Class 2 Permissive Change (C2PC) Request Letter

FCC ID: 2AXDT-RFM015, granted on 04/10/2024.
IC: 26428-RFM015, HVIN(s): RFM015, granted on 11/22/2023.

Reason: Hardware Change

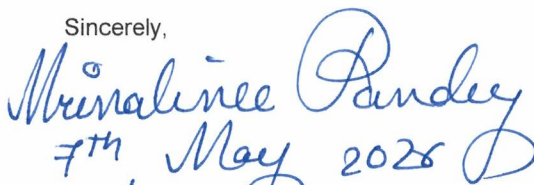
- Part substitution of BALUN filter is caused by product EOL (End-Of-Life), will be replaced with the manufacturer recommended BALUN. The new BALUN component is pin-for-pin compatible and has the same basic function as the BALUN (from an external perspective). No PCB change and No change in radio parameters have occurred, verified by RF Performance and Emission test conducted by FCC accredited Lab.
